# HISTORIC AND DESIGN REVIEW COMMISSION

May 17, 2023

**HDRC CASE NO:** 2023-081  
**ADDRESS:** 8623 OLD CORPUS CHRISTI RD  
**LEGAL DESCRIPTION:** NCB 10923 BLK 4 LOT N 58.17 FT OF 3A  
**ZONING:** R-6, H  
**CITY COUNCIL DIST.:** 3  
**DISTRICT:** Mission Historic District  
**APPLICANT:** ARMANDO H MARTINEZ/A D A INC.  
**OWNER:** ARCELIA SANDOVAL/SANDOVAL ARCELIA  
**TYPE OF WORK:** Review of demolition with replacement plans  
**APPLICATION RECEIVED:** February 28, 2023  
**60-DAY REVIEW:** Not applicable due to City Council Emergency Orders  
**CASE MANAGER:** Rachel Rettaliata

The applicant is requesting a Certificate of Appropriateness for approval to demolish the primary structure.

Re: Existing Structure Conditions  
8623 Old Corpus Christi Hwy.

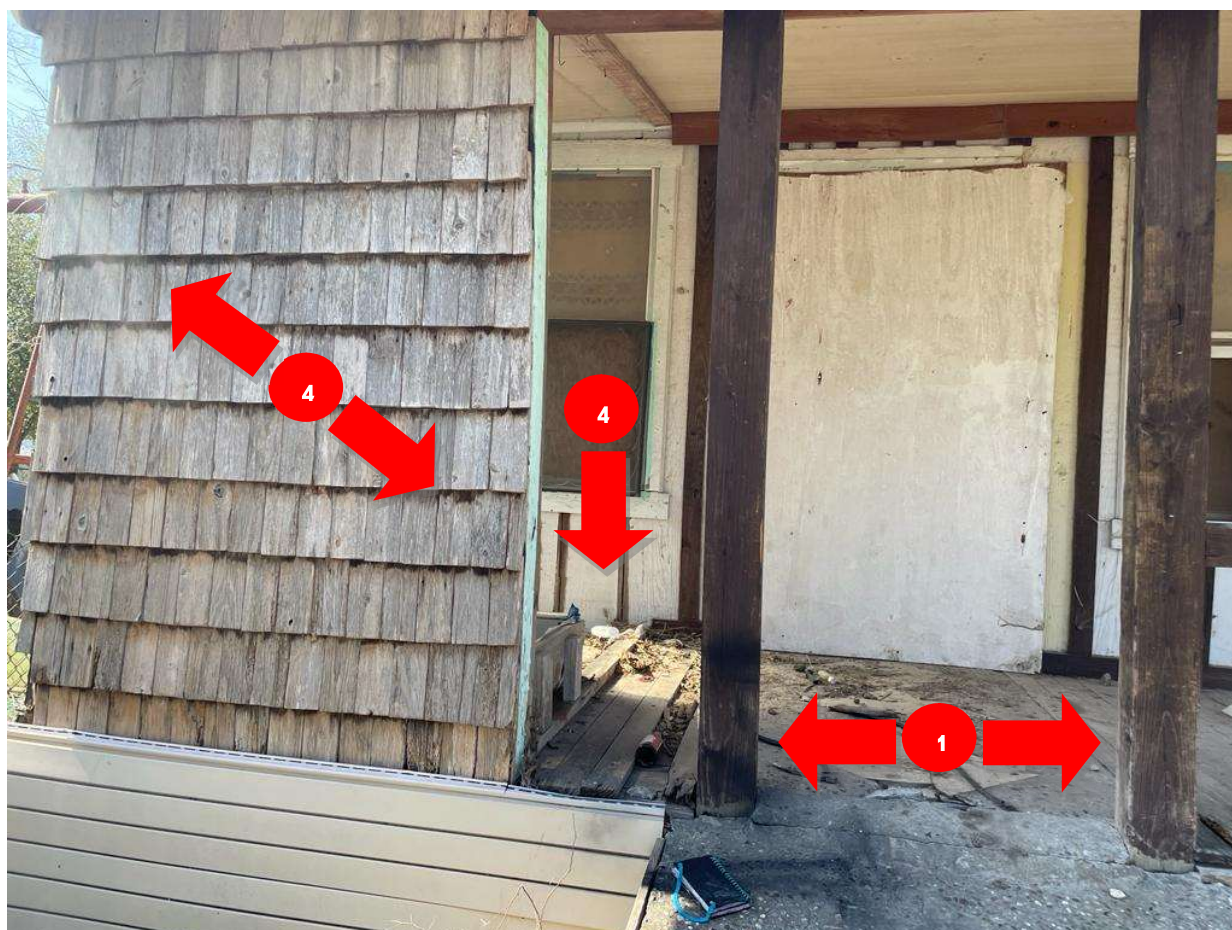
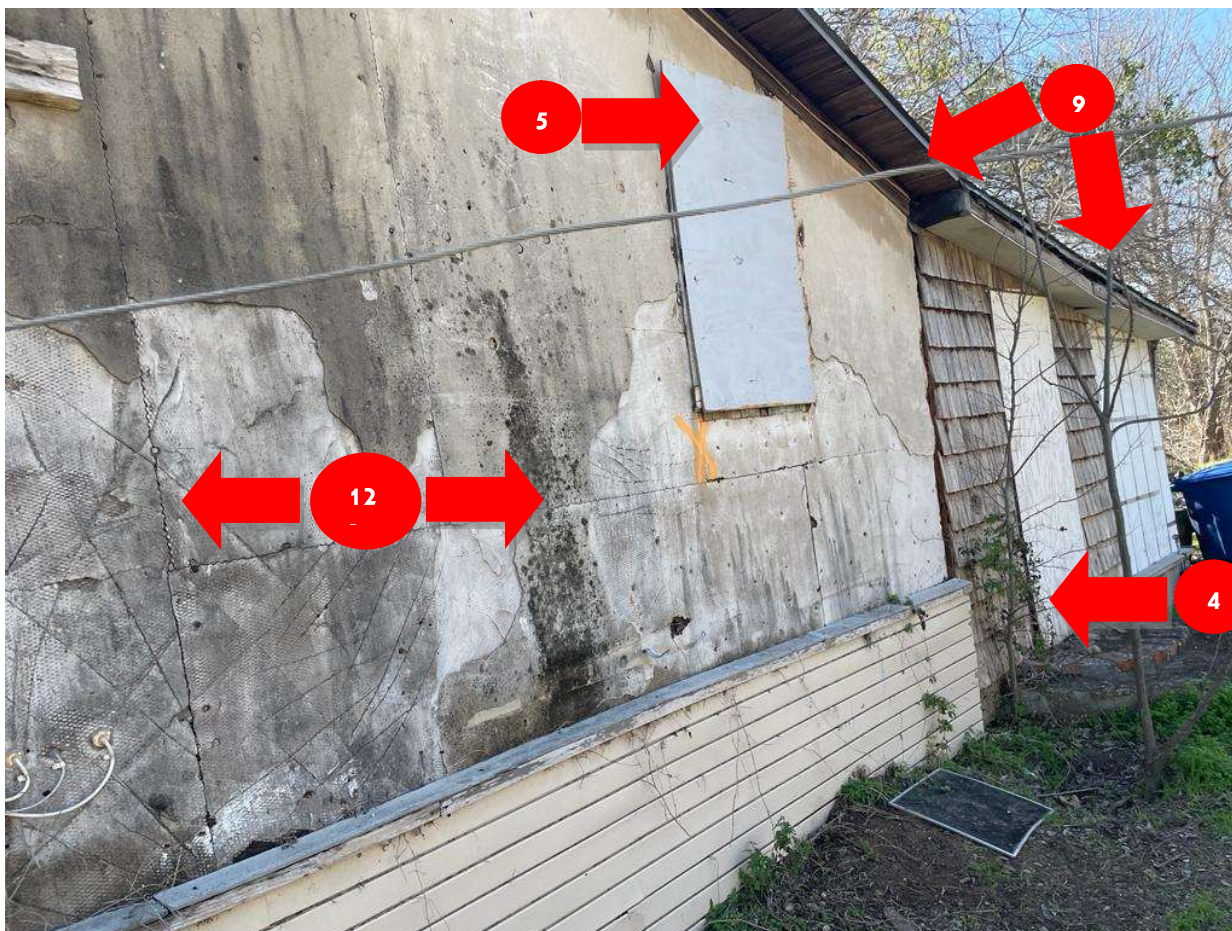
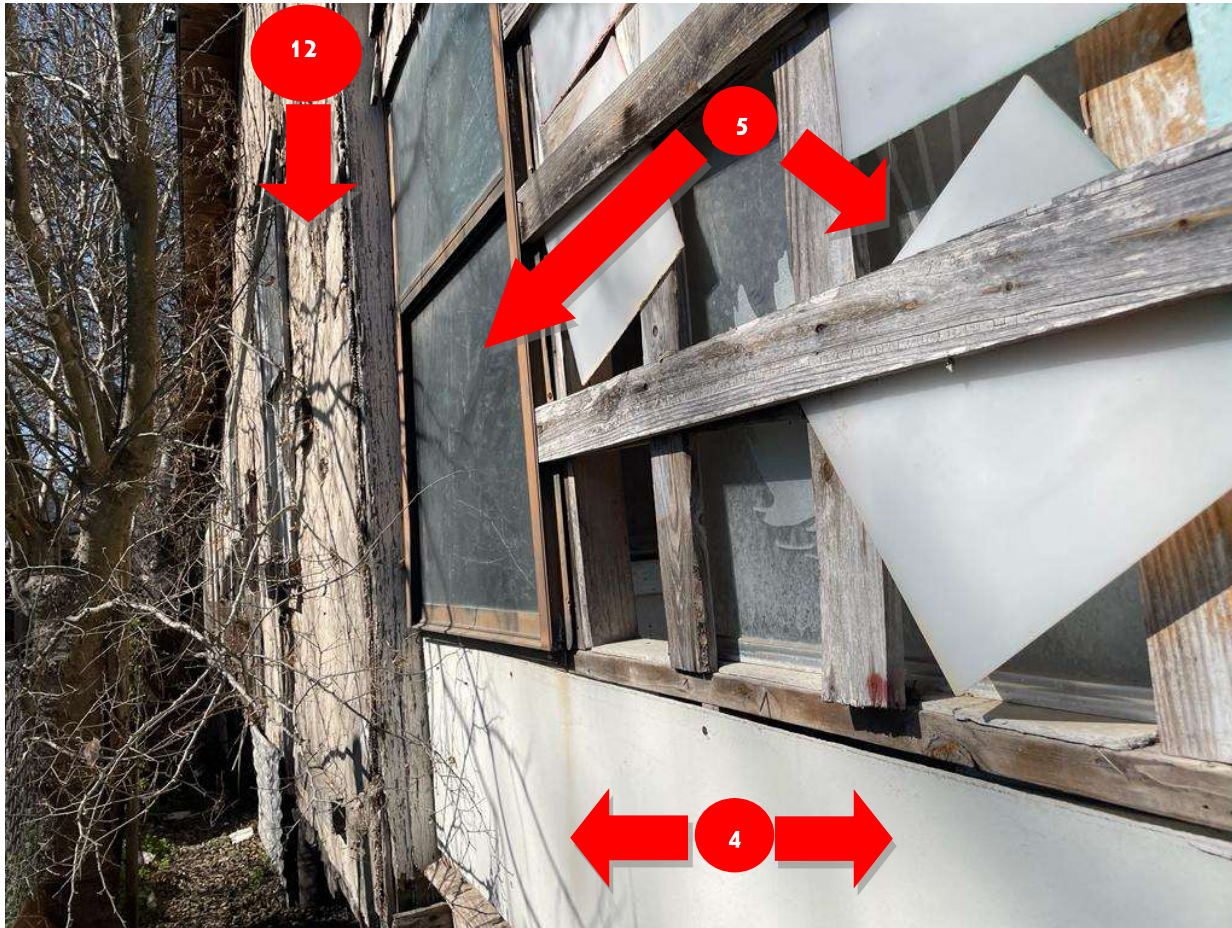
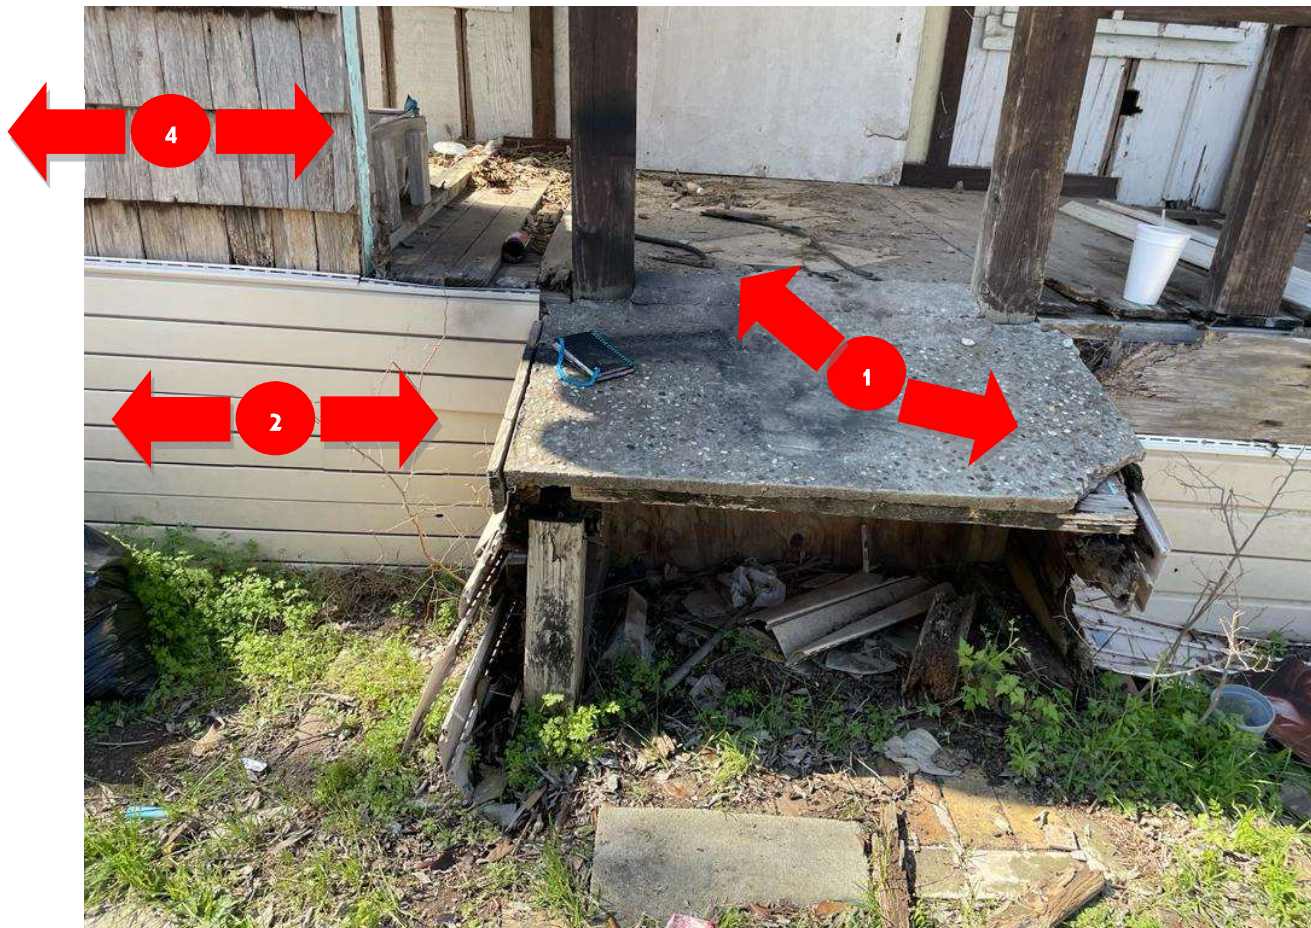
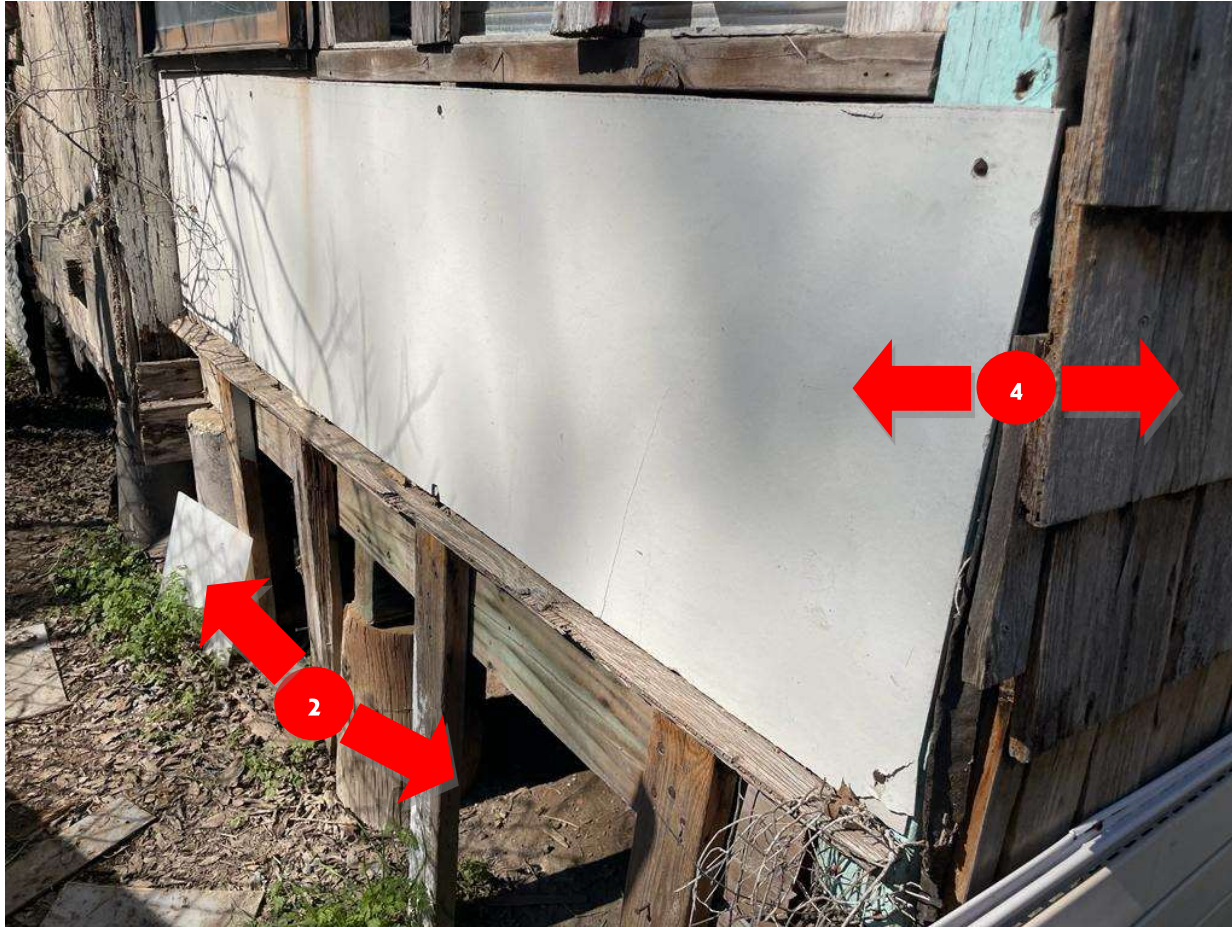
1. Existing wood deck needs to be replaced with foundation post replaced in new IBC code applicable.
2. Skirting below existing finish floor needs to be replaced.
3. Front elevation railings required to be replaced to meet code.
4. Existing siding requires to be replaced and be replaced by one pattern siding. existing siding needs to be removed.
5. Existing windows need to be removed and replaced with required windows meeting the code.
6. Existing structure has several types of roofs and requires new roof.
7. Observation of foundation footings requires replacement with new engineered design.
8. Structure requires new main framing that will meet the current code requirements.
9. Exterior fascia needs to be replaced and installed properly.

10. Existing structure does not have proper wall waterproofing barrier with base flashings. Existing porch needs new sub floor replacement.
11. Existing stucco requires replacement and to be replaced with selected siding.

12. Interior walls need to be properly spaced and plumed according to current code.
13. All existing sheet rock needs replacement with proper tape, float and texture painted.

14. Existing bathroom fixtures need replacement along with faucets and drains.
15. Existing plumbing vents and main drains do not meet current code.
16. Existing main sewer lines need to be replaced and in compliance with current plumbing code.

17. Sewer lines need to be connected to main sewer lines in compliance with code.
18. Existing structure is within 1' - 6" of the property in accordance recent property survey, (See attached Survey), this would not meet current city required side yard setback.

19. Existing wall within the 1'-6" side yard will have to meet one hour rated wall with no openings on such side.

Note: The above observations of visual inspections, justifies the recommendation of existing residential structure to be removed and demolish. Replacement of a suitable residential structure is present for review and approval.

2 SITE PLAN  
1" = 10'-0"

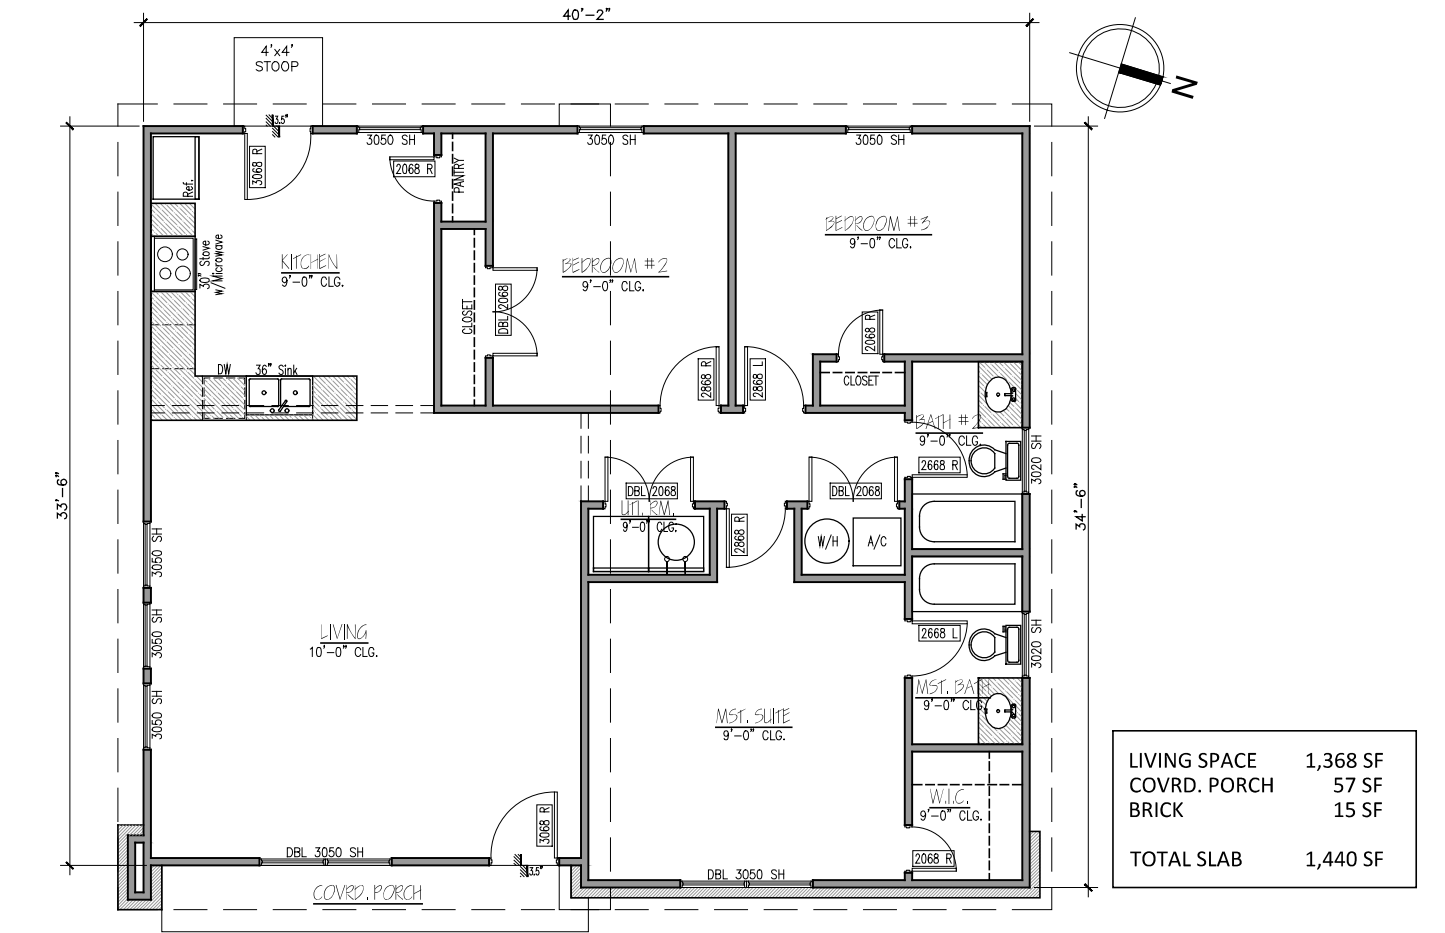
- i. **REPLACEMENT PLANS** – The applicant has proposed to replace the structure with a new 1-story primary structure. The applicant has proposed a 1-story, 1,440-square-foot, single-family residence. The applicant has proposed a composition shingle broken gable roof, Hardie board, stucco, and stone or brick veneer for the cladding material. The applicant has not provided window or door specifications at this time. The applicant has proposed to install an 18-foot-wide concrete driveway at the front of the property. Staff finds that the proposed new construction is inconsistent with the Guidelines and the documentation required for review of new construction is currently incomplete.
